Access Compliance Report Public Rights-of-Way (Pedestrian Signals)

Intersection ID: N/A	Main Street:	Cross Street: N/A	Location: N/A
ADA ID: 1B37EC6A89CA	Signal Type: One Push Button-Non APS	Overall Compliance: No	Severity Score: BTN 1: N/A BTN 2: N/A No BTN: N/A
Codes/Mitigation Info/Possible Solution		Field Measurements/Component Compliance

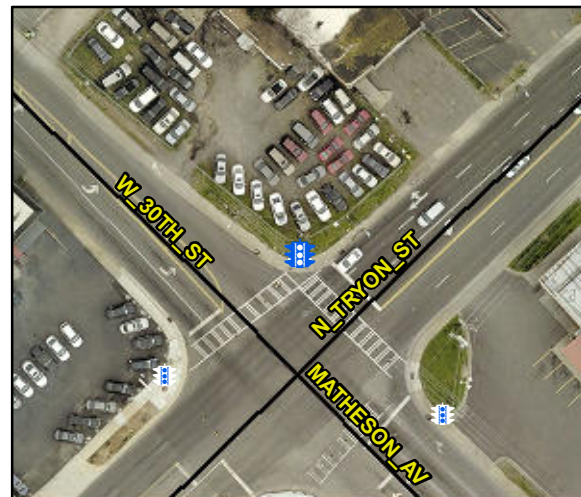
PROW/ADA: TMUTCD 4e.08, R209.1, R404.3, R404.2, R406.2, R404.7.3

No	B 1 Clear Xing Direction?	NotClearlyMarked	N/A	B 2 Clear Xing Direction?	N/A
	B 1 Crossing Direction	To SE		B 2 Crossing Direction	N/A
Yes	B 1 DistanceTo XWalk (in)	30.0	N/A	B 2 DistanceTo XWalk (in)	N/A
No	B 1 DistanceTo Curb (in)	73.0	N/A	B 2 DistanceTo Curb (in)	N/A
Yes	B 1 Diameter (in)	2.0	N/A	B 2 Diameter (in)	N/A

Possible Solutions: Replace Signal Push Button With APS Button on New Post. Remove & Relocate Sign.
